Review of Blackfriars Bridge

ETSC project – Voice

Søren Underlien Jensen
5th October 2005

Note

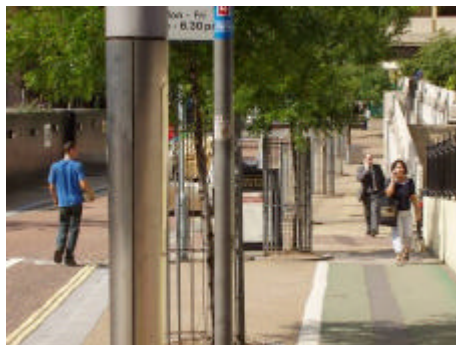
The dual-way cycle facility in the middle of Blackfriars Road between Upper Ground and Stamford Street is not used by most cyclists. This facility should be closed and the space should be used for other purposes.

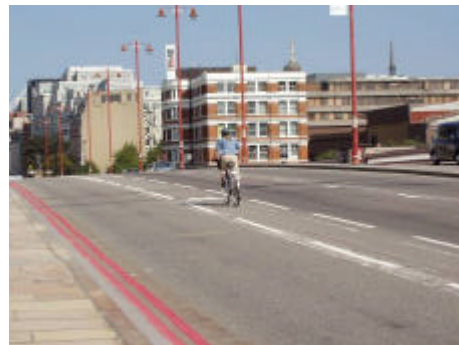
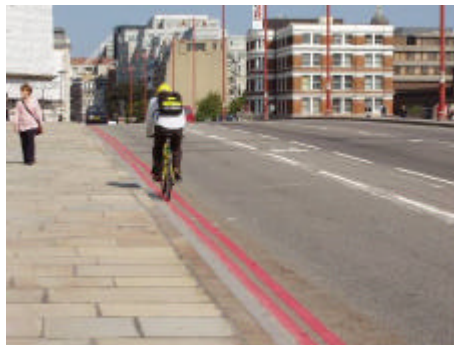
The northbound cycle lane is located between a left-turn lane and a continuing straight forward driving lane. Most cyclists use this lane, but merge into the cycle lane from a location near the kerb at various points across the bridge. This results in many improper lane changes. The reason for this is an unclear start of both the left-turn lane and the cycle lane. The left-turn lane is much too long compared to its traffic volume, and its markings at the start of this lane is “hidden” just after the bus stop. The cycle lane is too narrow in relation to having cars driving 20-35mph in lanes on both sides of the cyclist.
